## **ADDENDUM NO. 2**

DATE: January 2, 2020

PROJECT: Owosso Water Treatment Plant Wash Water Pump and Piping Replacement  
DWRP #7457-01

OWNER: City of Owosso

**2 DISCHARGE PIPING**  
 1/4" = 1'-0"

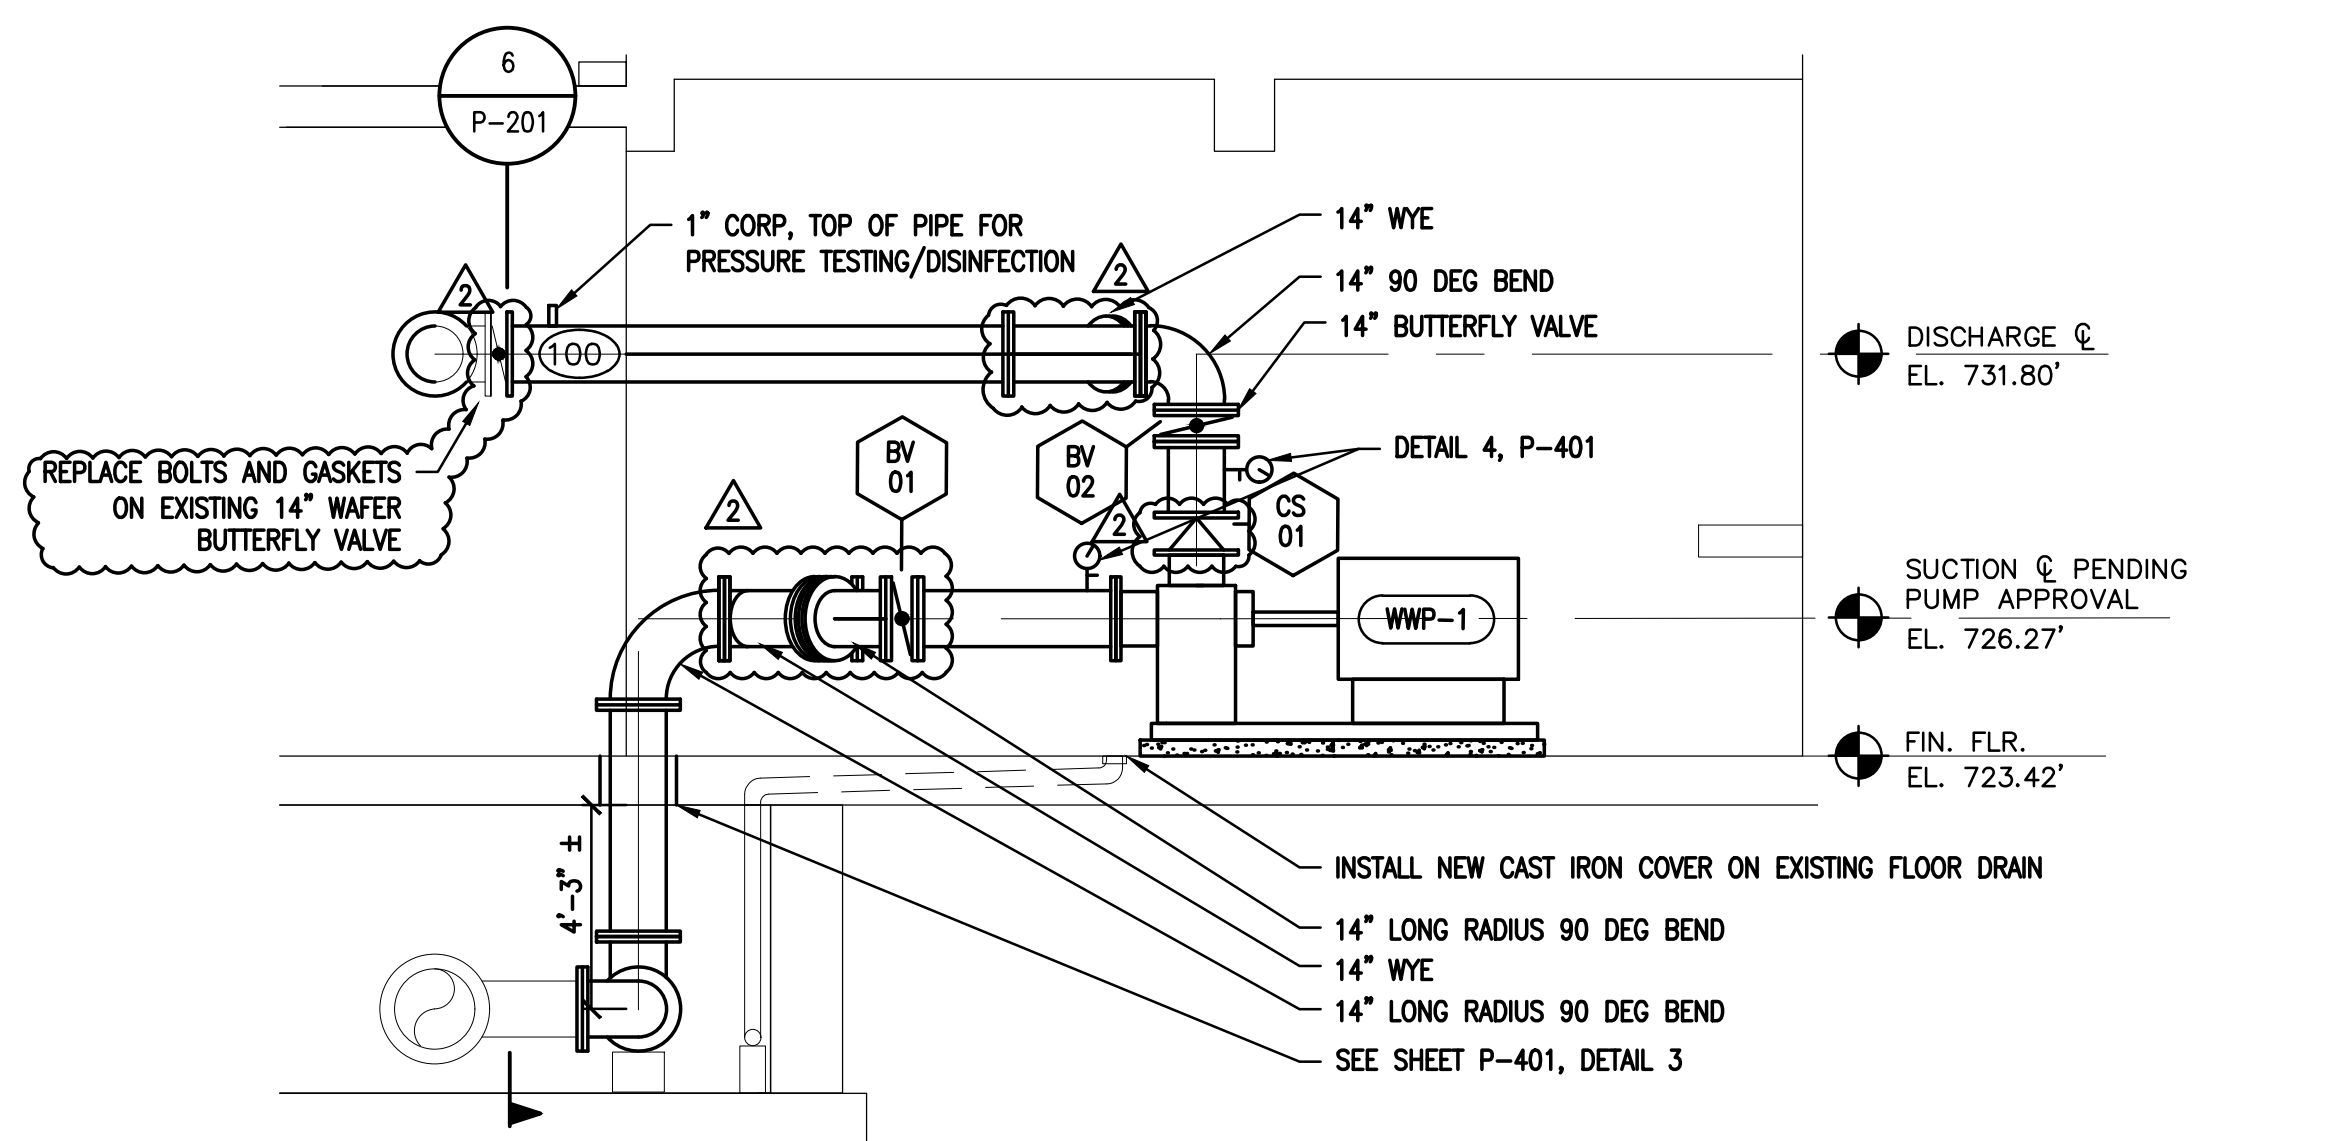
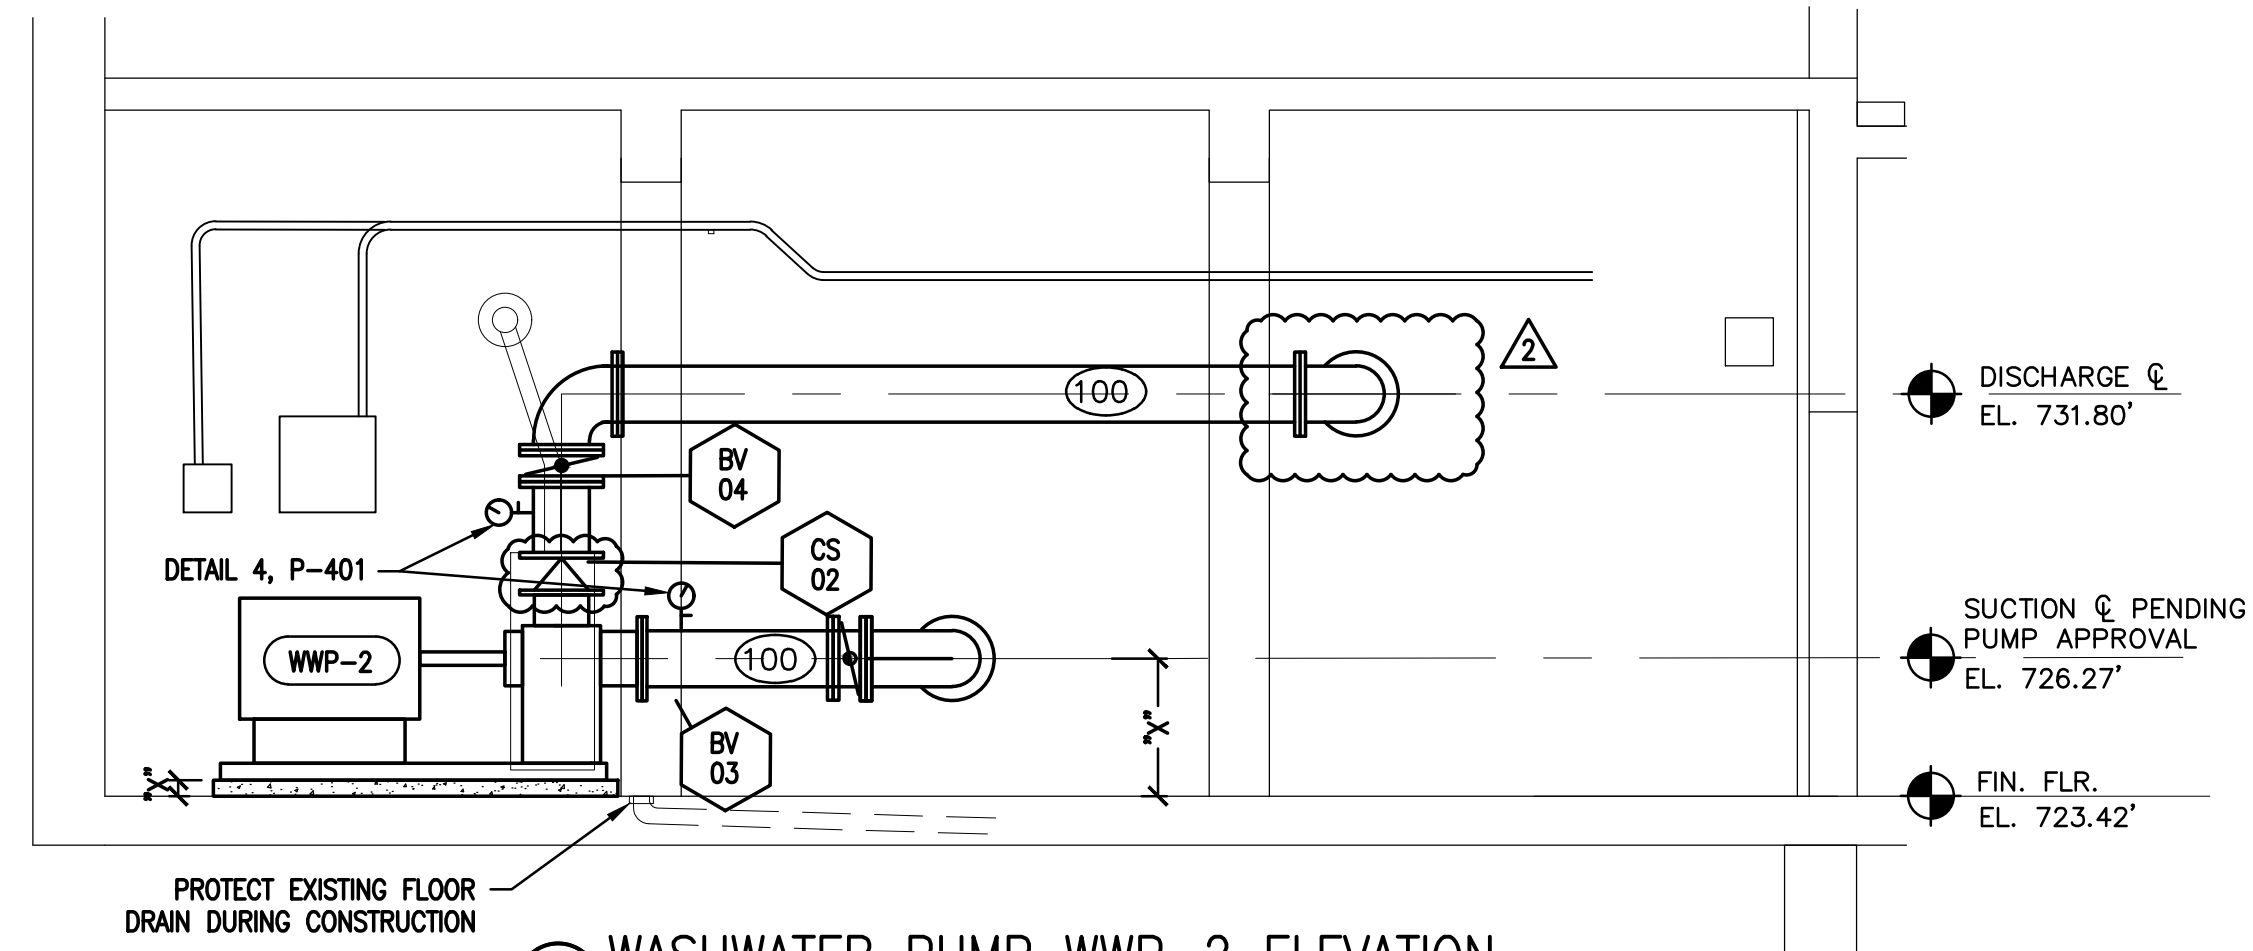
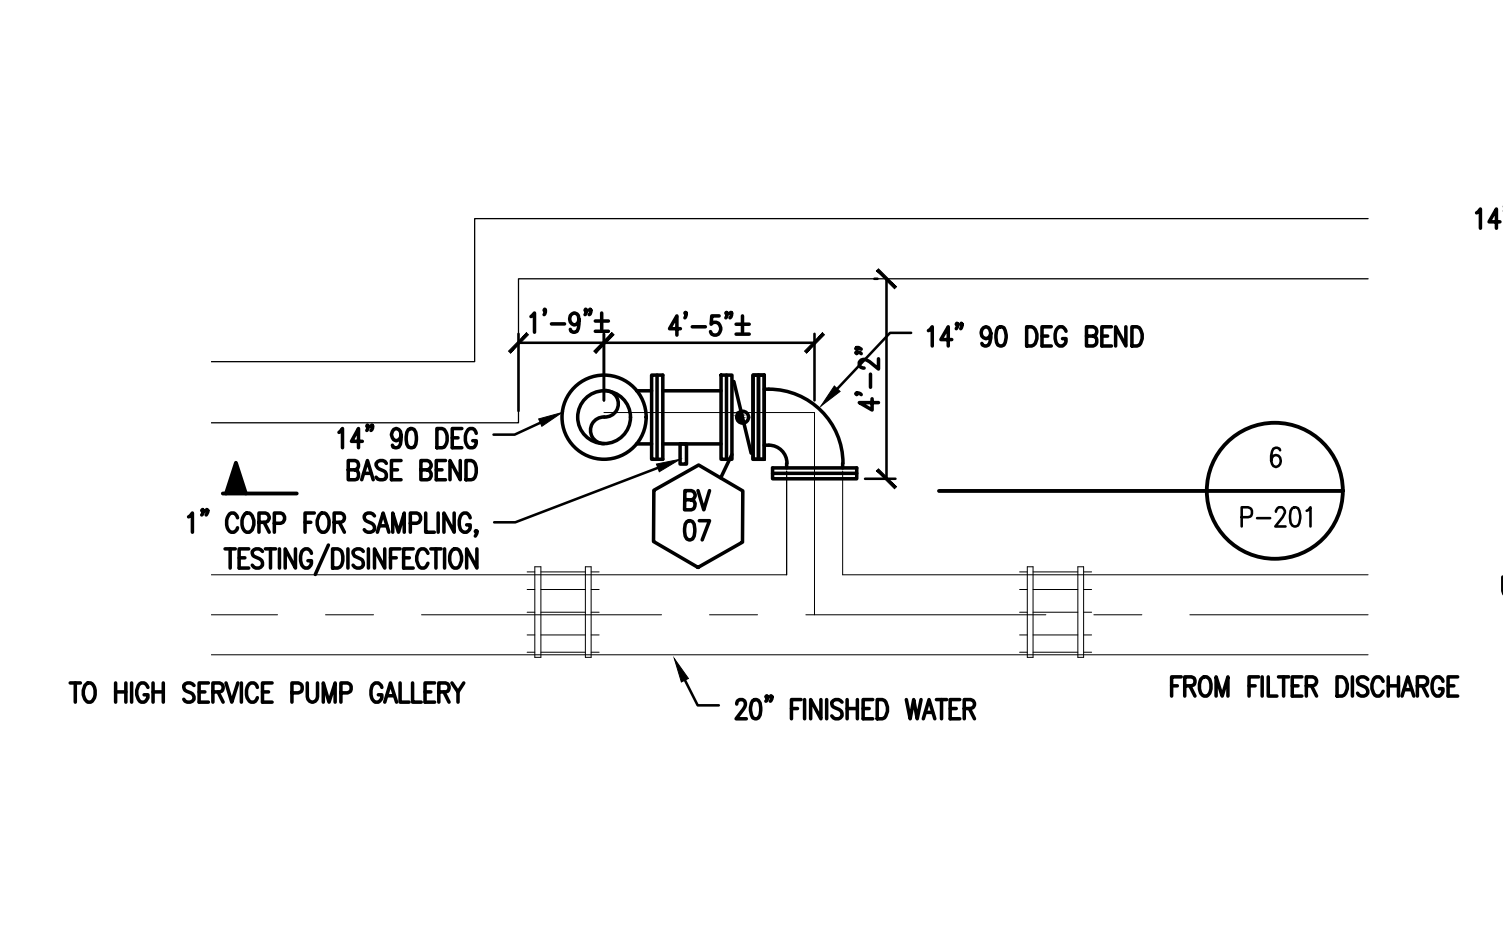
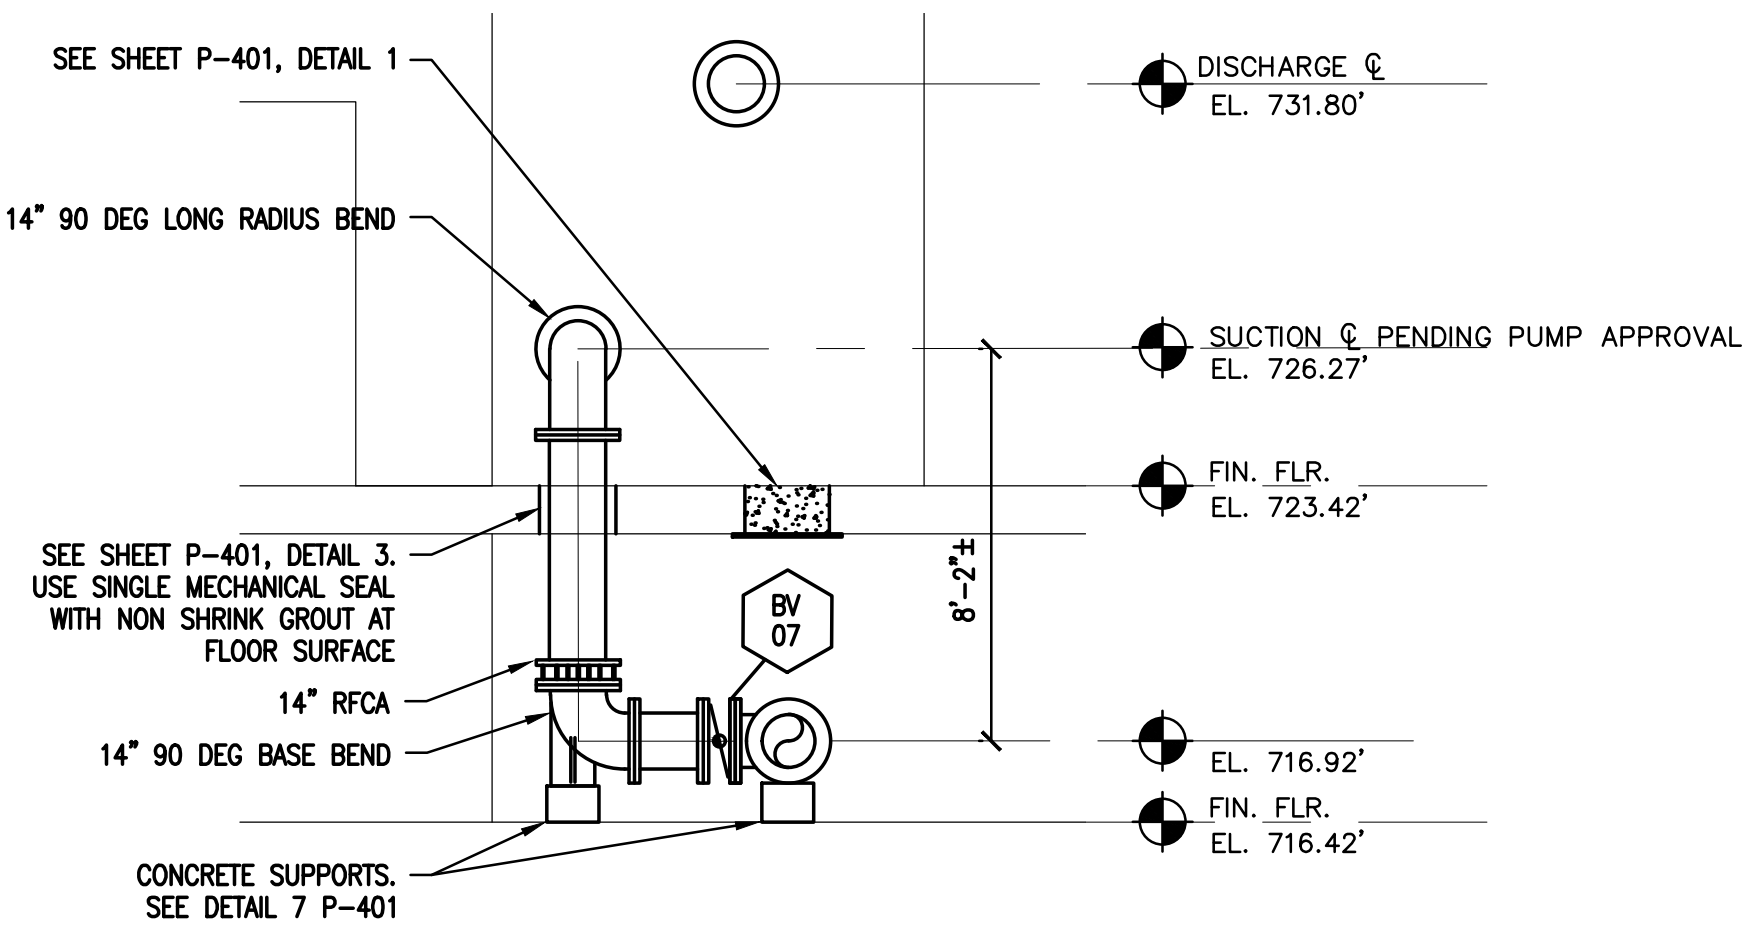
- 3. SHEET P-201 WASH WATER PUMP & PIPING PLAN & SECTIONS. Remove and replace this sheet.
- 4. SHEET P-203 HIGH SERVICE PIPE PLAN. Remove and replace this sheet.
- 5. SHEET P-301 PUMP, VALVE & PIPE SCHEDULES – change the following valve accessory
